Staff Report

Tentative Subdivision Plat

SD-01-24

May 10, 2024

**TENTATIVE PLAT
 TENTATIVE SUBDIVISION
 SUNNY LANE TOWNHOMES**
 MAP 105-AW-3540
 TAX LOT 400
 ALBANY, OREGON

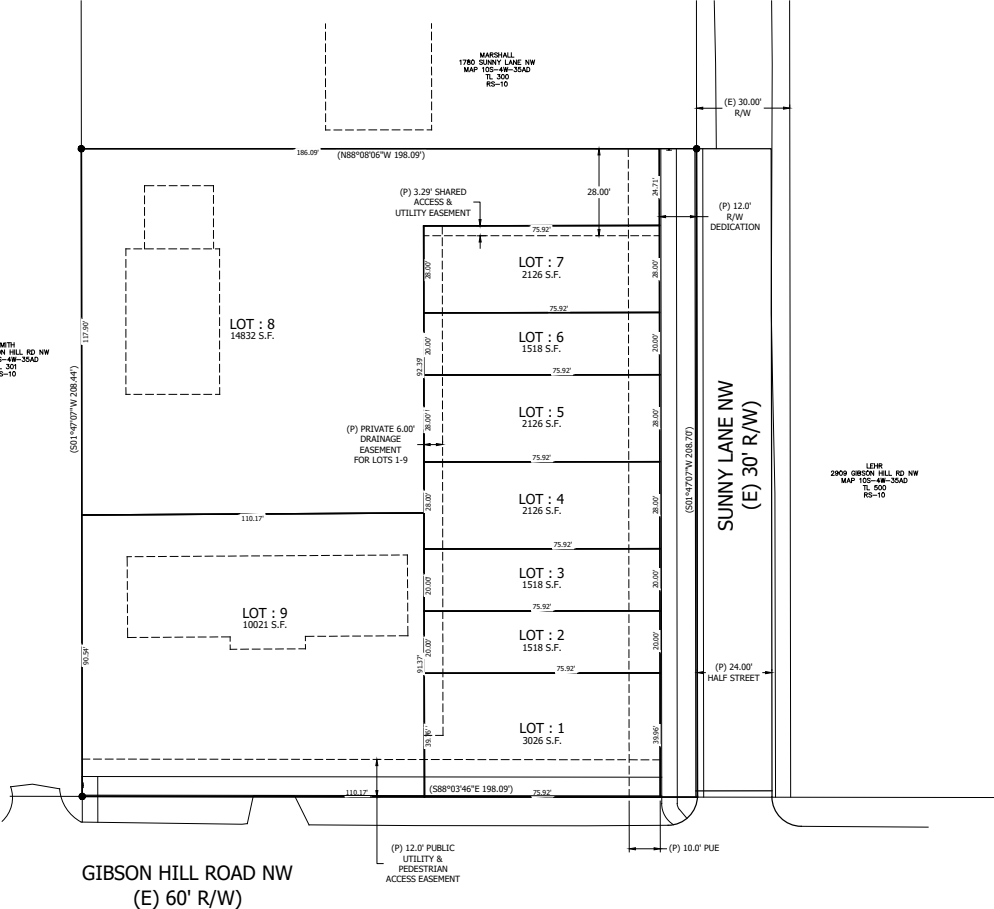
- 4.4 The partial width improvement of NW Sunny Lane will provide for a vehicle travel lane in each direction, but until the east side of the road is eventually improved there will be insufficient room for on-street parking along the west side of the road. Based on the proposed driveway locations, the only gap in driveways long enough to allow for a potential parking space is between townhome lots 4 and 5. Installation of a "No Parking" sign at that location is needed to prevent vehicles from parking there until the eventual improvement of the east side of the road.

- 4.1 As shown on the Tentative Plat, lot lines run at right angles to the streets, or radial to the curved portions of the streets.

- Condition 3 Prior to recording the final plat map, the applicant shall construct or financially assure the construction of partial width street improvements along the site's frontage on NW Sunny Lane. Improvements shall be consistent with the approved site plan and consist of:

- A curb, gutter, and sidewalk along the west side of the street. The curb alignment shall reflect an ultimate curb to curb width of 30 feet centered within a 54-foot right of way.

- The construction of the driveway approaches as shown on the approved site plan.
 - The construction of pavement to meet city standards with a width of 24 feet as measured from the west face of curb.
